LEO
V2.800.0000000.20.R.201124

Release Notes

Item	Description
Product name	LEO platform overseas 5/4/3 series product
Version	V2.800.0000000.20.R.201124
Software package information	General_IPC-HX5(4)XXXL-Leo_MultiLang_NP_Stream3_V2.800.000000.20.R.201124.zip General_IPC-HX5(4)XXXL-Leo_MultiLang_PN_Stream3_V2.800.000000.20.R.201124.zip General_IPC-HX5(4)(3)XXX-Leo_MultiLang_NP_Stream3_V2.800.000000.20.R.201124.zip General_IPC-HX5(4)(3)XXX-Leo_MultiLang_PN_Stream3_V2.800.000000.20.R.201124.zip
OS requirement	None
Release date	2020/12/28

Figure 1-1 Optimization effect

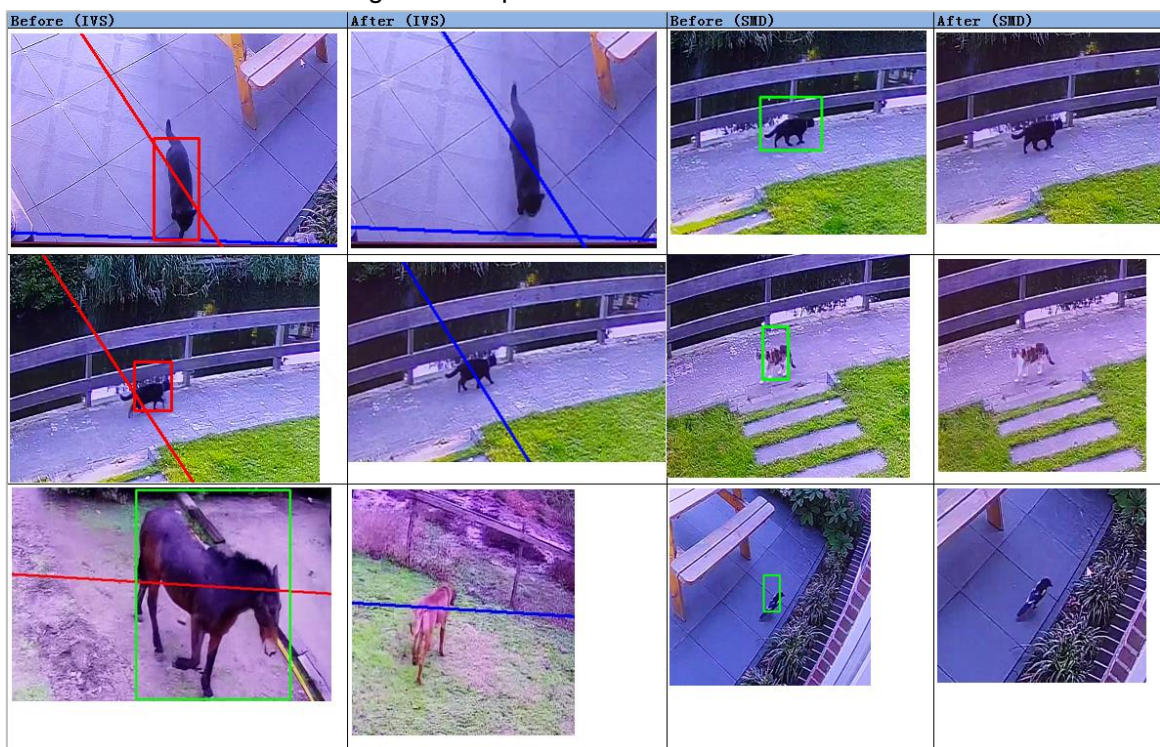
Optimize animal detection of SMD and IVS functions of the released 3 series network camera.

- At present, IVS and SMD are mainly for human and vehicle detection, and it has no detection model for animal. With the training of massive data, the model is optimized.
- When you enable IVS and SMD, false alarm will occur when an animal is detected. After optimizing the algorithm model, false alarms caused by animals will be filtered when the target is human or vehicle.

For the optimization effect, see Figure 1-1.

Figure 1-2 Delete scene changing

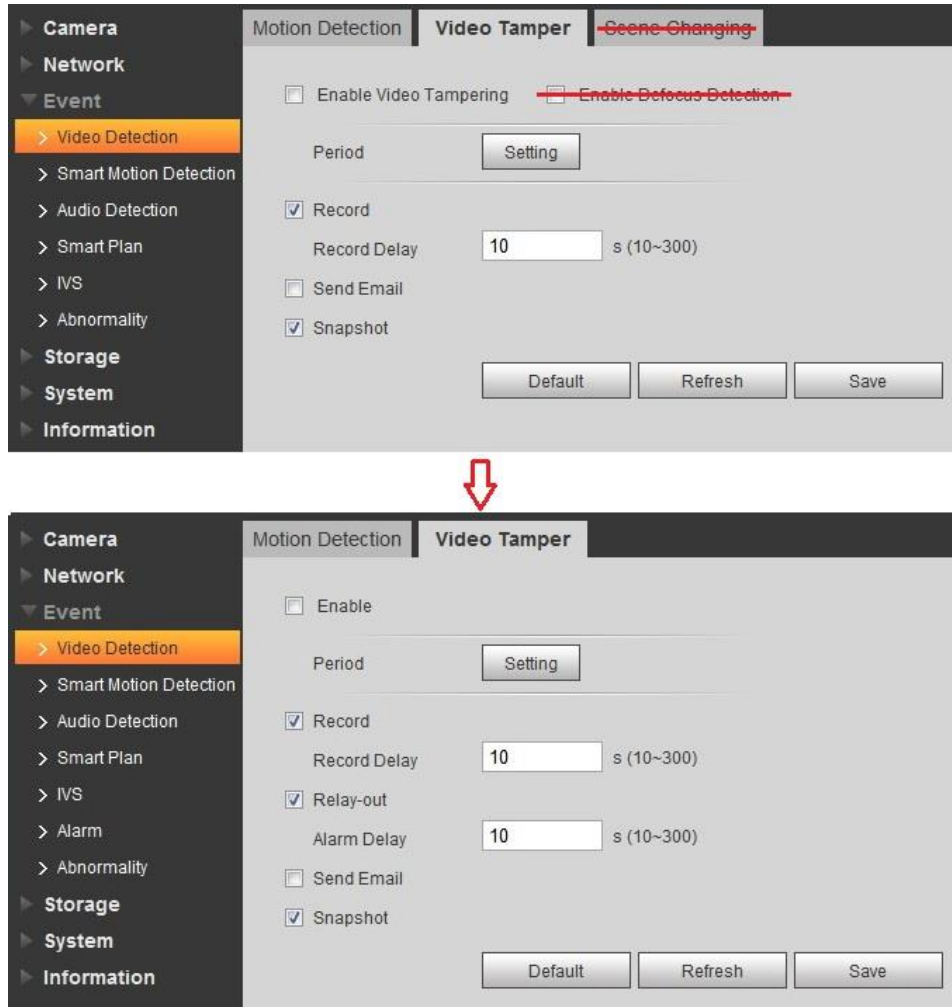
- Because of the storage shortage of the series 32 devices after SMD and IVS optimization, scene changing and defocus detection functions are deleted.

Figure 1-3 Legal information on web

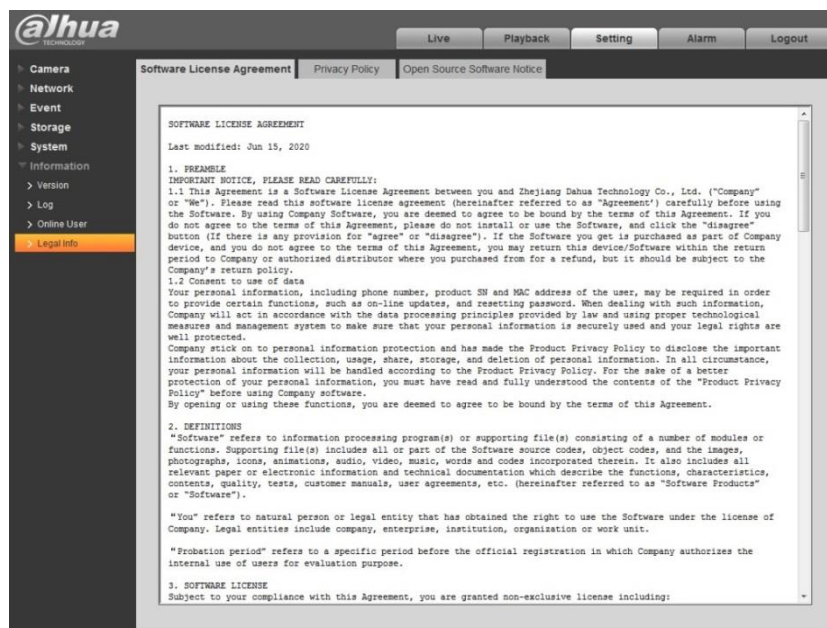
As the company requirements of device compliance, software license agreement, private policy and open source software notice need to be displayed on the device.

Figure 1-4 Disabled (default) audio

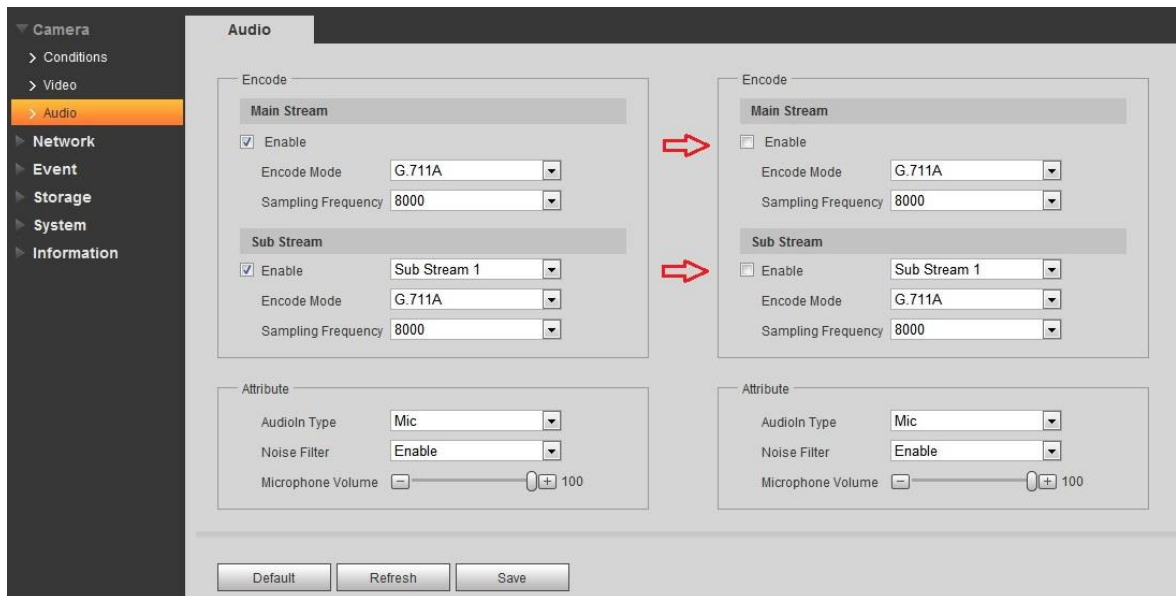
Audio is disabled by default, because collecting audio without informing others is illegal in some areas.
